SERVICE BULLETIN

ENGINE - L.P. COMPRESSOR - REPLACE THE NO.3 BEARING HOUSING ASSEMBLY SHOULDER STUDS WHICH HAVE BEEN SHOT PEENED - CATEGORY CODE 5 - MOD.ENG-72-0059

V2500-ENG-72-0059

Location of No.3 bearing housing assembly shoulder stud
Fig.1

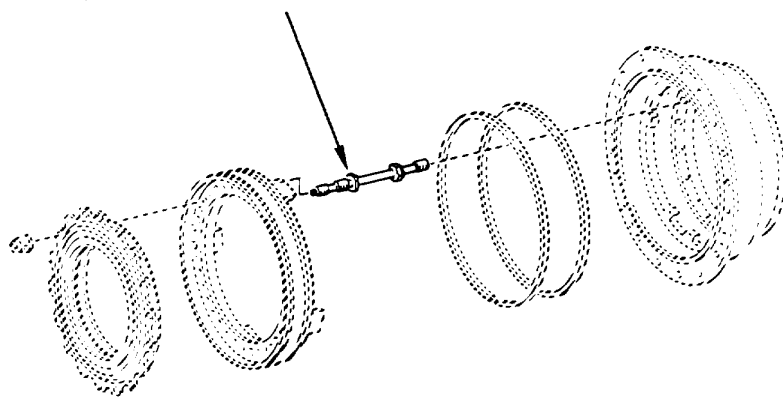
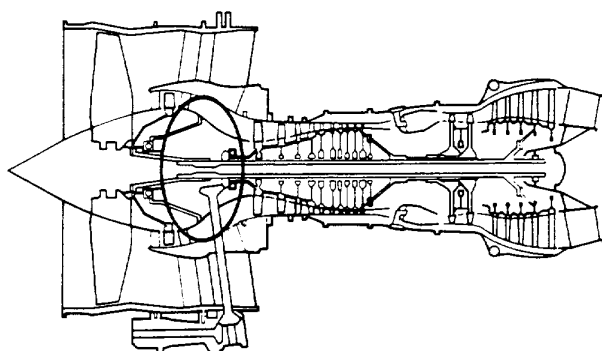
- (1) Remove the 2A0422 No.3 Bearing Housing Assembly Shoulder Studs by the instructions given in Reference (2), Chapter/Section, 72-32-20 Removal. Refer to Figure 1.

- (1) Install the 2A1667 No.3 Bearing Housing Assembly Shoulder Studs (18 off) by the instructions given in Reference (2), Chapter/Section, 72-32-20 Assembly.

REMOVE THE PN 2A0422
SHOULDER STUD AND INSTALL
PN 2A1667 SHOULDER STUD (18 Off)
